# Long MPS timings v110

Lennart Yseboodt — March 11, 2019

Figure 33–10—PSE monitor inrush and monitor MPS state diagrams

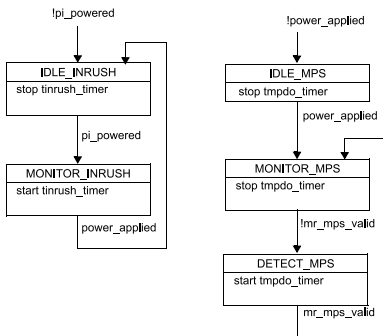
There is a discrepancy between a requirement in text (33.2.9.1.2) and the behavior of the state diagrams. The state diagrams alone cause an interoperability issue with the PD MPS timings.

The final requirement allows the MPS pulse to be adjacent to the  $T_{MPDO}$  window, whereas the the state diagram requires the pulse to reside inside the  $T_{MPDO}$  window.

There are two solution approaches, we can either change the text (and  $T_{MPDO}$  timings) to match with the state diagram, or we can make the state diagram agree with the text. This slide is the first option, see David Abramson's presentation for the state diagram solution.

1. Change  $T_{MPDO}$  min from 300 ms to 320 ms  
This matches the values in 802.3bt and covers the 10 ms we are short plus another 10 ms for the capacitive effect.
2. Change  $T_{MPDO}$  max from 400 ms to 460 ms.
3. "The PSE shall not remove power from the port when  $I_{Port}$  is greater than or equal to  $I_{Hold}$  max continuously for at least  $T_{MPS}$  every  $T_{MPS} + T_{MPDO}$  in the  $T_{MPDO}$  window, as defined in Table 33–11. This allows a PD to minimize its power consumption."

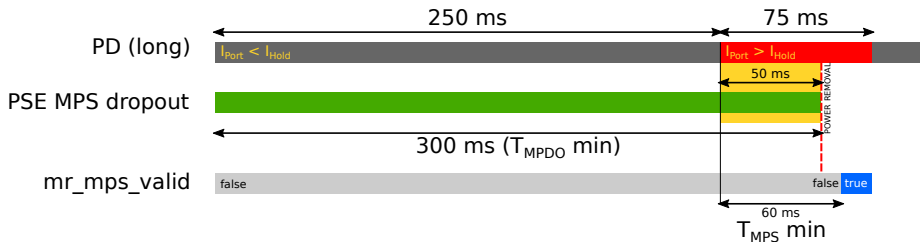
With an  $T_{MPDO}$  of 300 ms and a minimum duty cycle PD, the PSE will only have seen 50 ms worth of  $I_{Port} > I_{Hold}$ . The state diagram and the text at this point require it to remove power.

Simultaneously, the second text requirement requires power to be maintained for at least  $T_{MPDO} + T_{MPS}$ .

We need  $T_{MPDO\_PD} + T_{MPS} < T_{MPDO\_PD}$  ( $250 \text{ ms} + 60 \text{ ms} < 300 \text{ ms}$ ) which is currently not the case.
